**DRAWING OF
OUR GROUND-
LEVEL SETUP
HERE.**

Bell Mounting Assembly

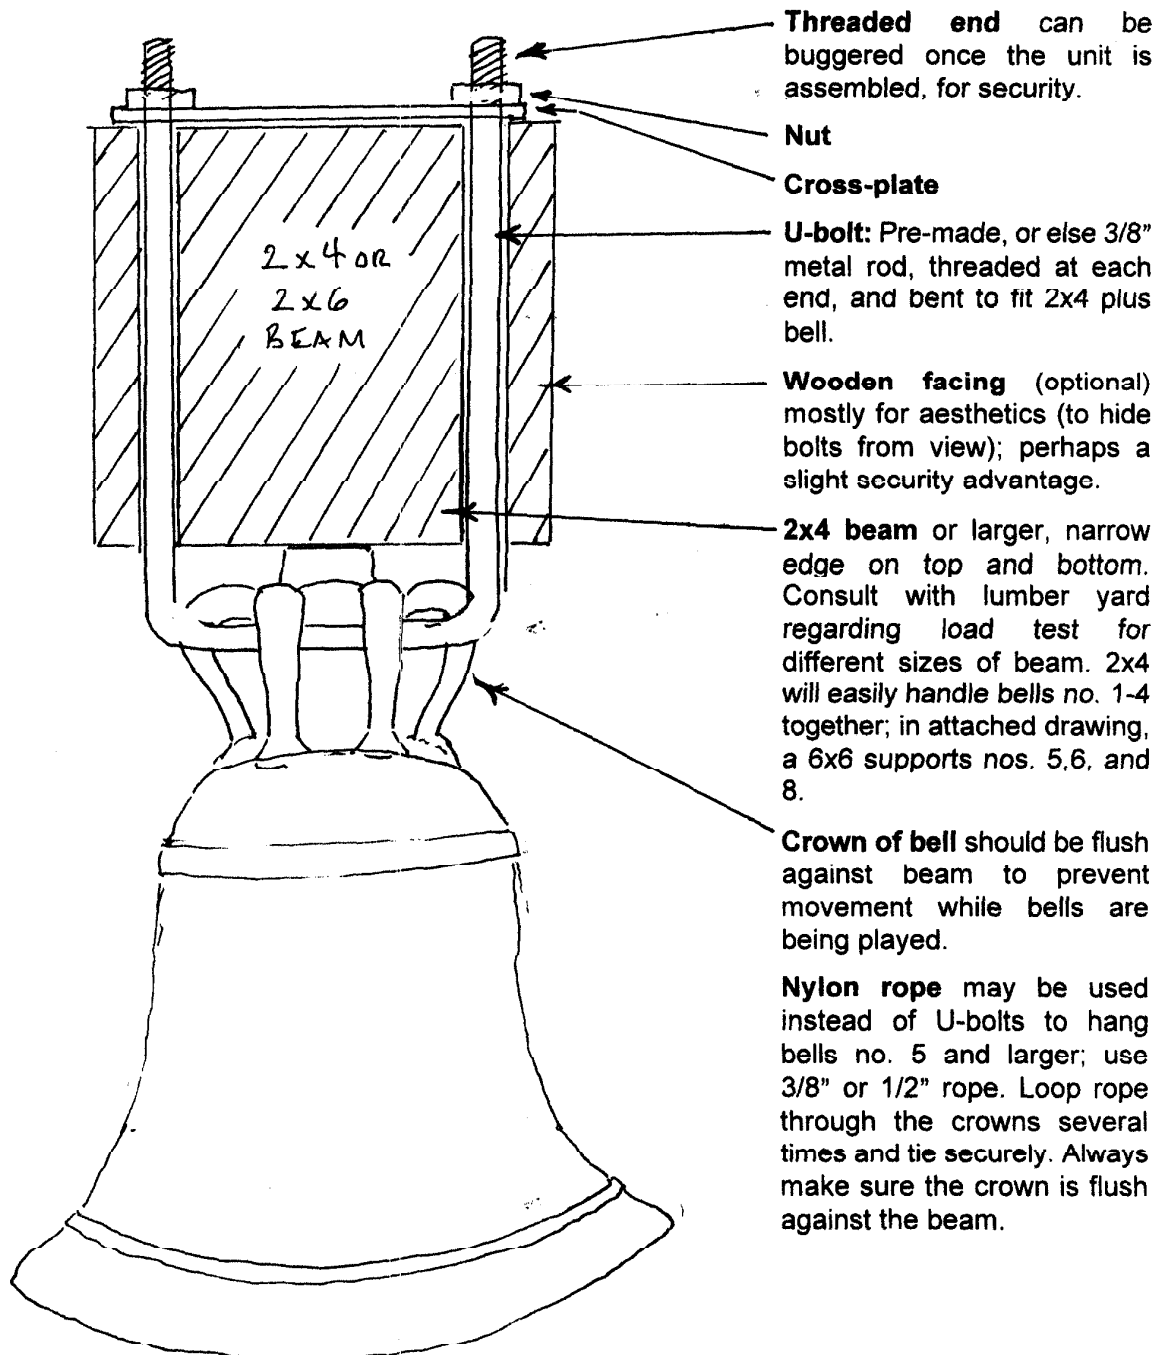
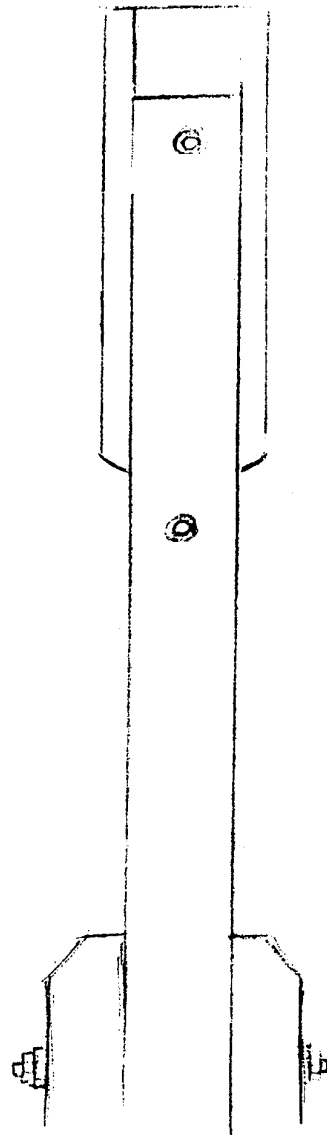
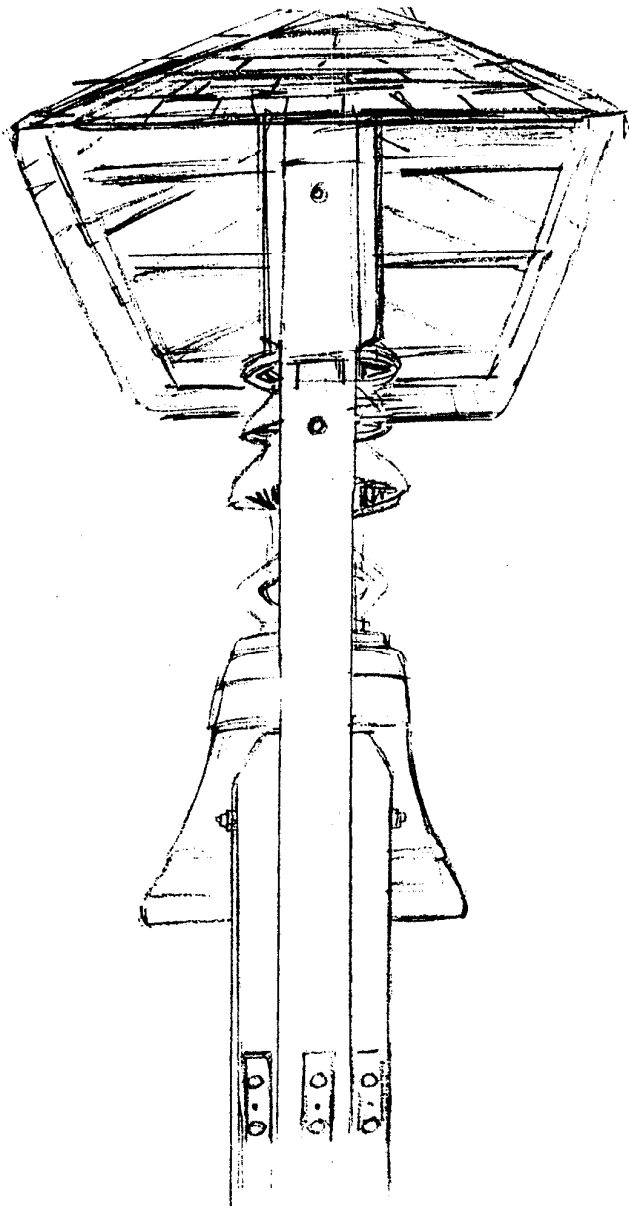
NOT SHOWN
CORRECTLY!
CROWN SHOULD
BE FLUSH AGAINST
BEAM!

The crown of each bell should be snug
against the beam from which it hangs.

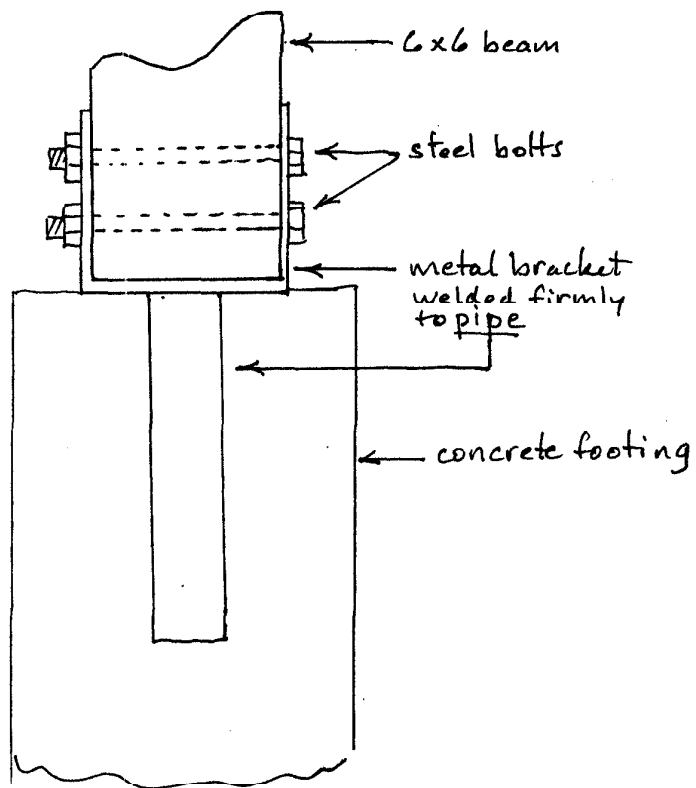
This is how the footers are made. In our climate, it is desirable not to set a wooden beam directly into the ground because the dampness of the soil will inevitably cause the beam to rot.

↑ Our setup is actually only 1' wide, but I noticed Holy Myrrhbearers made theirs about 3' long, at a right angle to the zvonitsa frame.

Good idea!
